**2 Type of change**

V-Lock cord retaining feature as standard.

CD Power Entry Module with Filter					0118.2258	
creation date	created by	release date	released by	notification no.	revision	page
2015-01-14	hollenpe	2015-06-08	hollenpe	26910	-	1 of 2

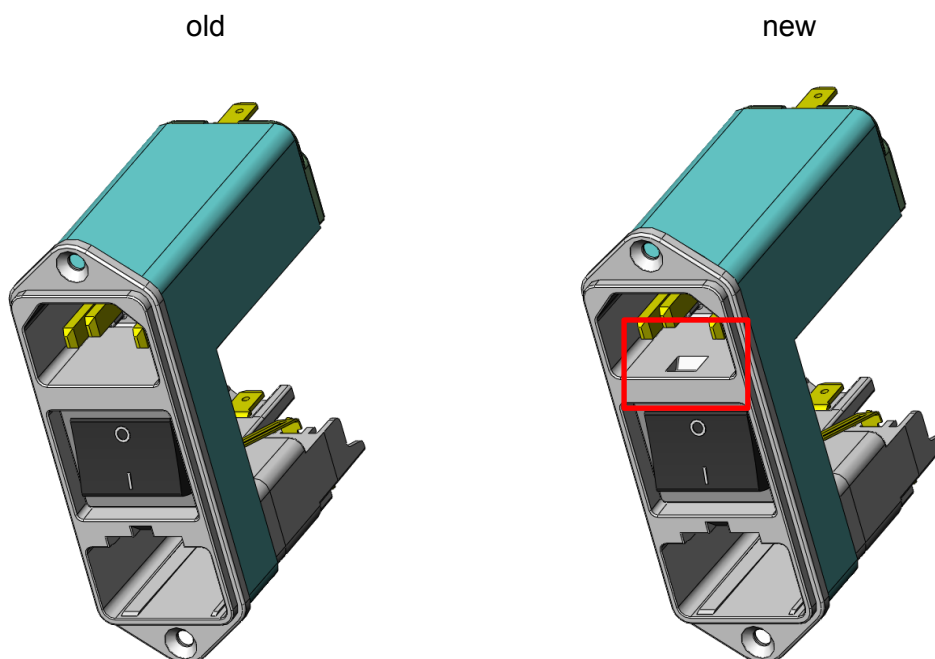
V-Lock feature integrated as standard (not an option anymore)

Form: Yes C14 inlet with V-Lock notch as standard  
 Fit: No There are no dimensional changes  
 Function: Yes V-Lock feature is standard (not an option anymore)  
 Production Site: No There are no change of the production site  
 Product Label: No No change of the product label

As the V-Lock is now a standard feature, the material numbers with index .21 are obsolete and will be replaced by the standard number:

CD61.1501.151.21 → CD61.1501.151  
 CD64.1101.151.21 → CD64.1101.151  
 CDC4.4101.151.21 → CDC4.4101.151  
 CDE4.4101.151.21 → CDE4.4101.151  
 CDM4.4101.151.21 → CDM4.4101.151
